**PLANNED UNIT DEVELOPMENT
STAFF REPORT****Date: March 20, 2008****DEVELOPMENT NAME**

Pintail Properties, LLC

LOCATION1206 Montlimar Drive
(West side of Montlimar Drive, 300'± South of Montlimar Plaza Drive).**SUBDIVISION NAME**

CONTEMPLATED USE

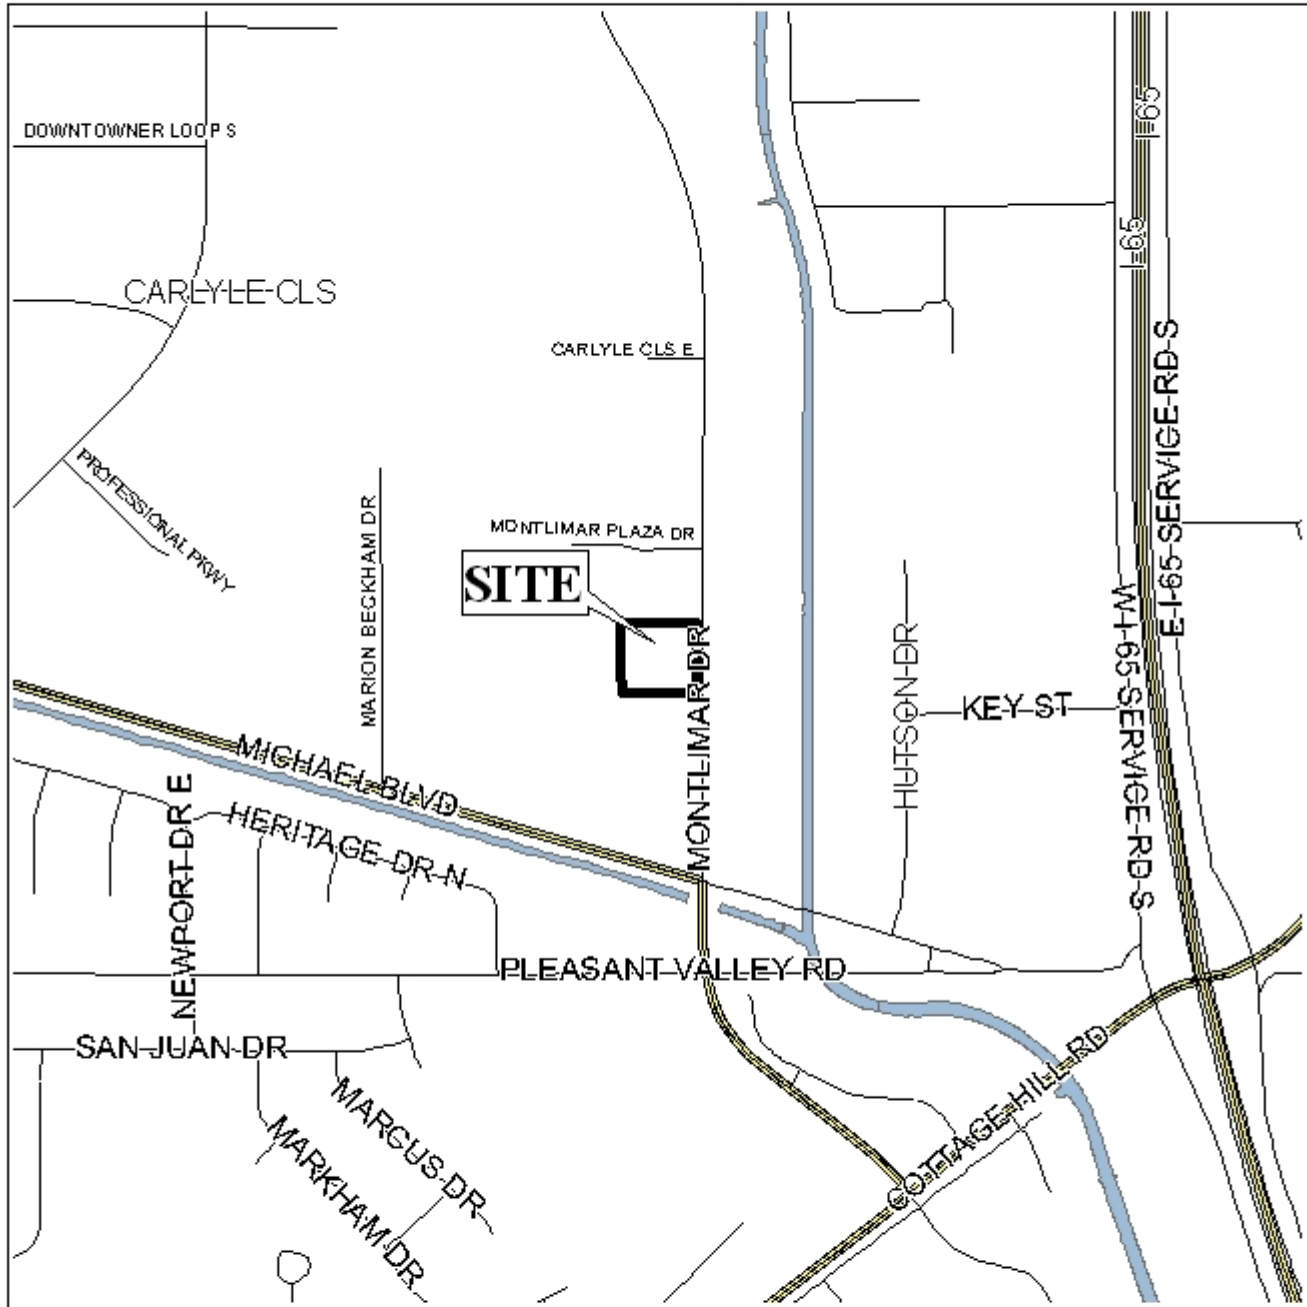
The PUD aspect of this application is the shared access and parking between the three sites; however, each site is compliant with the required parking ratios. The previously approved PUD for the two Northernmost sites was limited to a one-way traffic circulation to and through the rear of the properties. There was no cross-site traffic circulation in the fronts. This is now revised to indicate full access between all three sites via a compliant 24'-wide aisle connecting all front parking areas. The one-way circulation to and through the rear of the two Northernmost sites is still retained. The third (proposed) site would have access to the front and rear parking areas via a compliant 24'-wide drive, also affording access to the front parking areas of the other two sites, and the rear of the middle site.

The entire site abuts residential development to the West, and the existing and proposed parking areas contain more than 10 spaces; thus the parking areas must comply with Section 64-4.A.2. of

the Zoning Ordinance, *Illumination of uses*, which states “*Lighting facilities used to illuminate signs, parking areas, or for other purposes shall be so arranged that the source of light does not shine directly into adjacent residence properties or into traffic.*” and Section 64-6.A.3.c. *Lighting*, which states that “*if they contain ten (10) or more cars, lighting shall be provided and maintained during their operation, and shall be so arranged that the source of light does not shine directly into adjacent residential properties or into traffic.*” The site plan indicates a compliant 6’ wooden privacy fence proposed along the entire Western property line adjacent to the residential development. Dumpsters are indicated to be compliant with separation from the residential development, but the dumpster along the South property line should be relocated inward to allow 5’ from the fence enclosure to the property line.

- 1) placement of a note on the site plan stating that all lighting of the site and the parking areas will be in compliance with the requirements of Sections 64-4.A.2. and 64-6.A.3.c. of the Zoning Ordinance and provision of photo metrics to illustrate that lighting shall comply;

- 3) revision of the site plan to indicate a 5’ setback off the South property line for the dumpster enclosure on Lot 4;
- 4) provision of one (1) copy of the revised site plan to the Planning Section of Urban Development prior to a request for land clearing or building permits; and
